ITEM FOR ENVIRONMENTAL COMMISSION AGENDA

NAME & NUMBER OF PROJECT: 3801 Westlake
SP-2019-0243DS

REQUEST: Variance request is as follows:
Request to vary from LDC 25-8-281(C)(2)(b) to allow construction
of a boat dock and shoreline access within a 150-foot Critical
Environmental Feature (CEF) buffer for a Rimrock CEF.

3801 WESTLAKE DRIVE
PROPOSED CONDITIONS SITE PLAN
AND EROSION CONTROLS SHEET

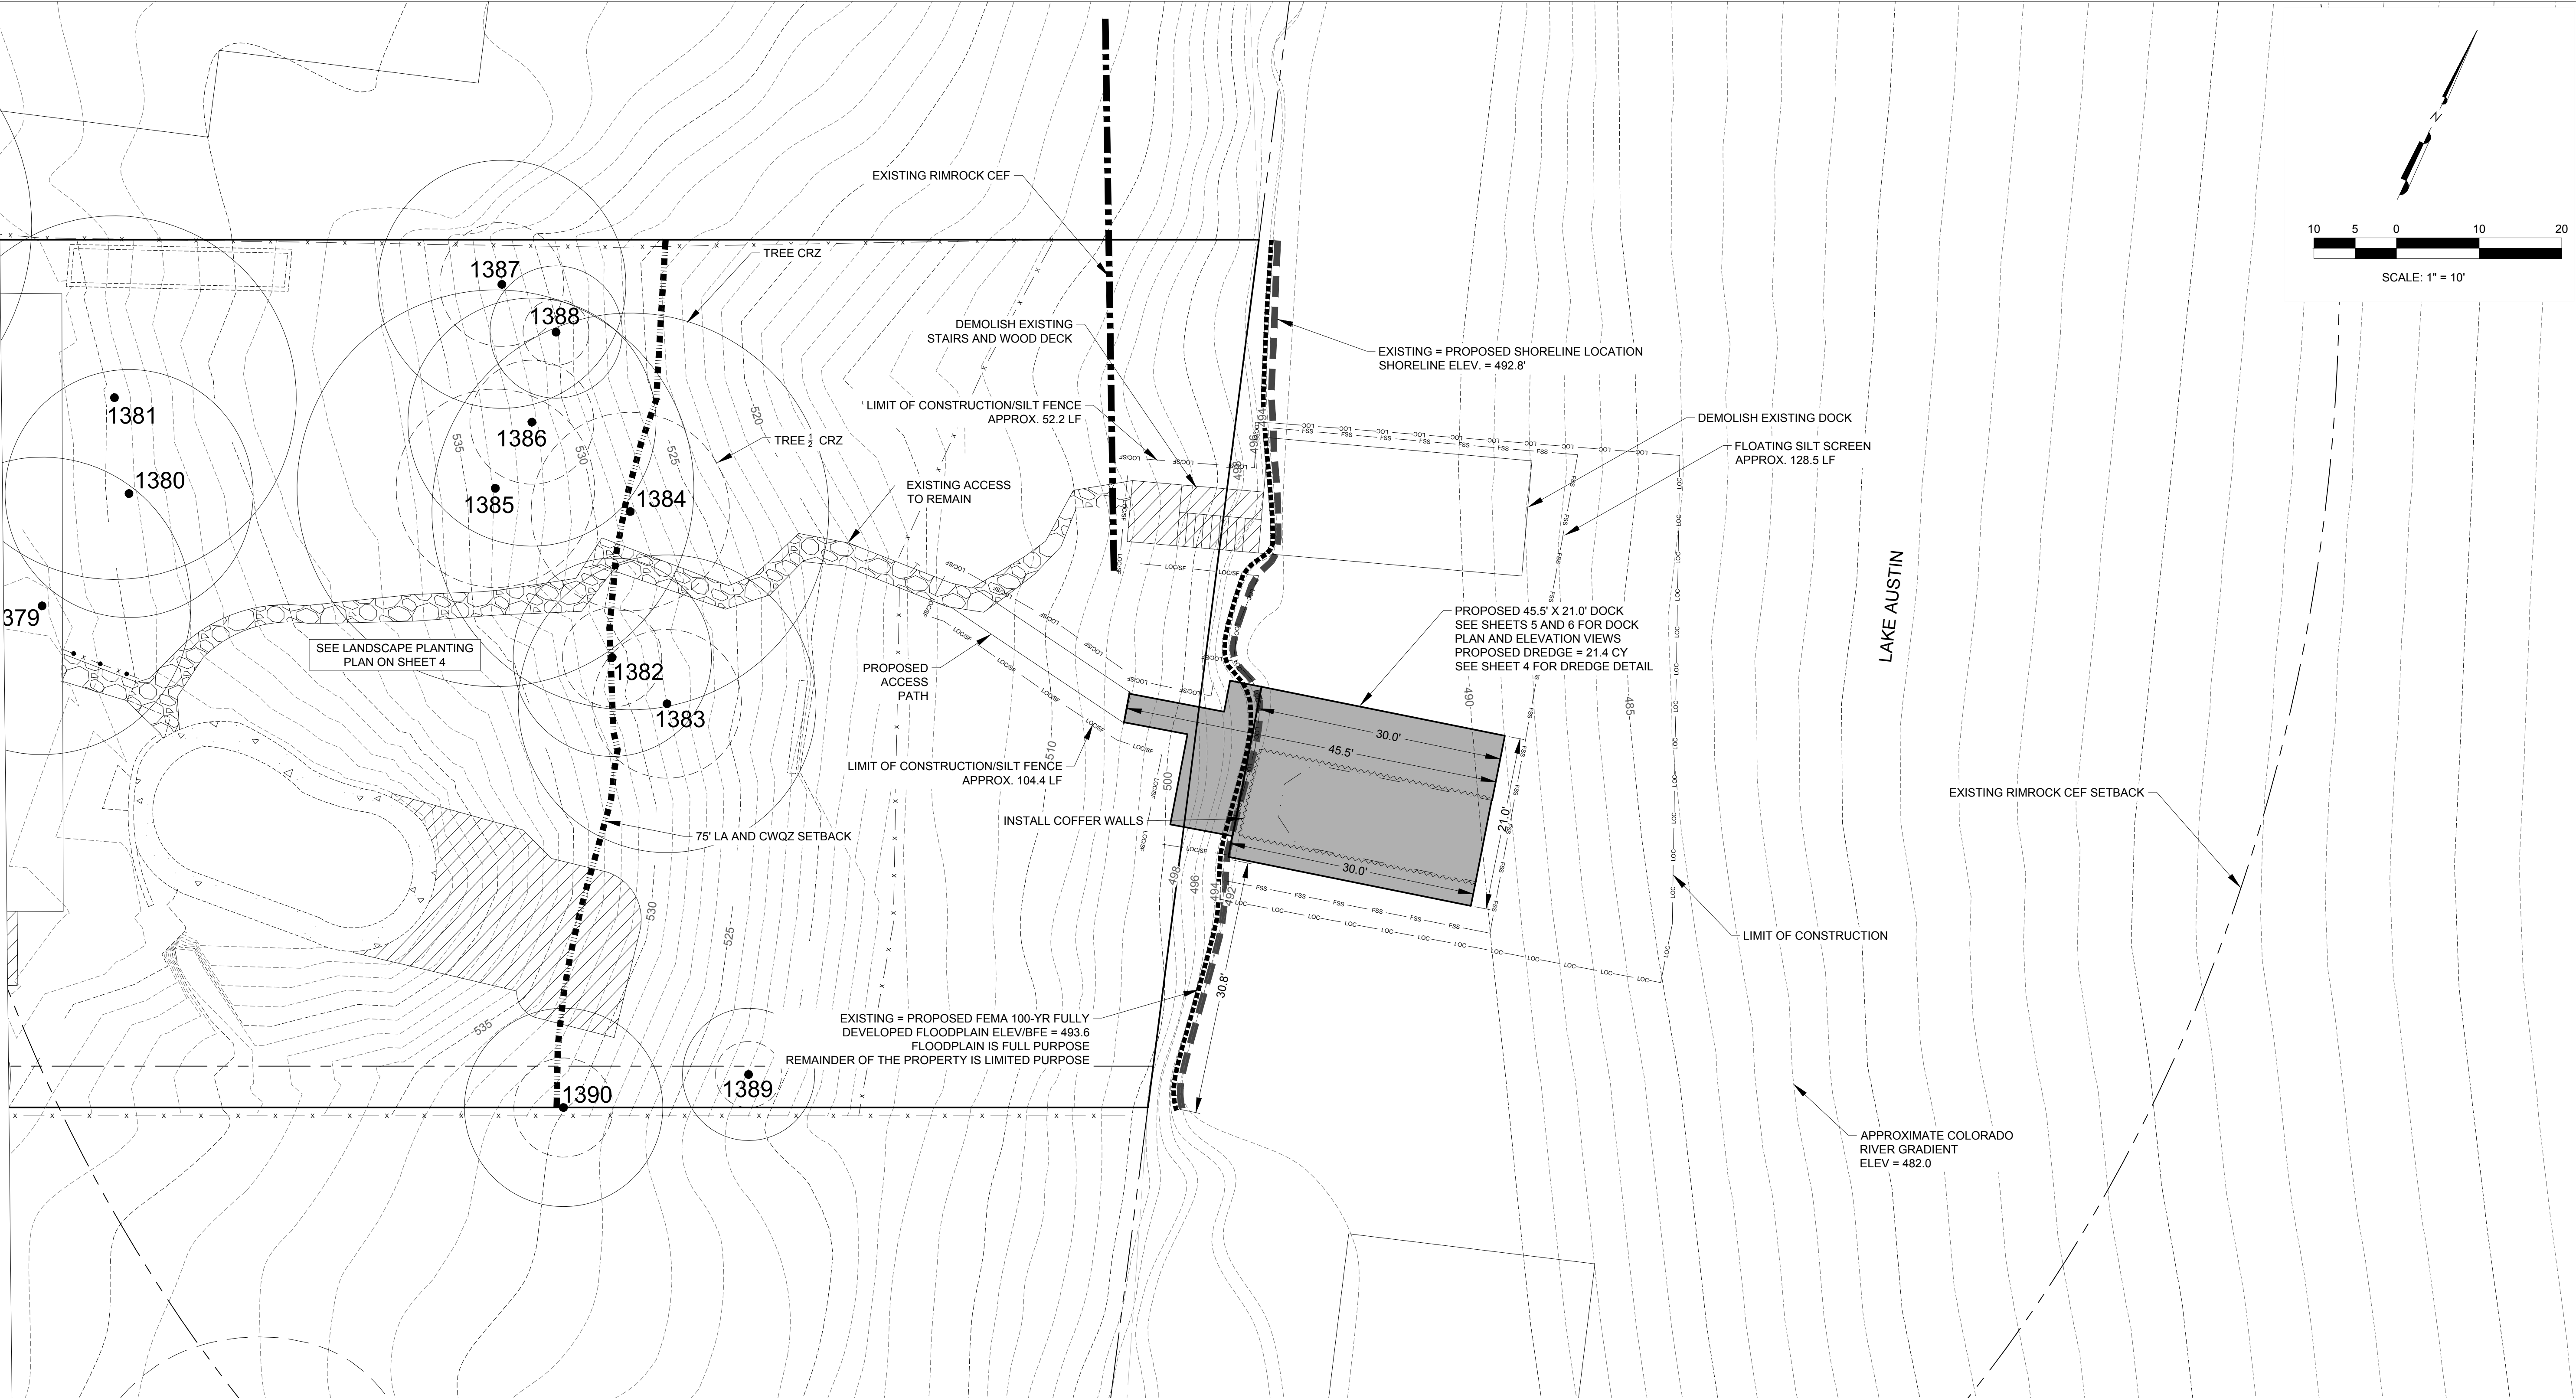
1. The portion of the existing access path that will be bypassed, between the point where the new path will branch off from the existing path and the endpoint of the current path where it connects with the current bridge, shall be removed and revegetated.
2. In the plan set, a non-erodible surface (e.g., paving, shallow stairs, etc.) for the proposed path shall be specified.

Yes. The variance is not necessitated by the design. No alternative locations outside of the CEF buffer are available on site for shoreline access because the entire shoreline for this property is within the canyon rimrock CEF buffer. Additionally, the applicant is proposing a more favorable location for shoreline access than the current boat dock, for which the access crosses the canyon rimrock. All areas of demolition and construction within the

Staff Determination: Staff determines that the findings of fact have been met. Staff recommends the following condition:

1. The portion of the existing access path that will be bypassed, between the point where the new path will branch off from the existing path and the endpoint of the current path where it connects with the current bridge, shall be removed and revegetated.
2. In the plan set, a non-erodible surface (e.g., paving, shallow stairs, etc.) for the proposed path shall be specified.
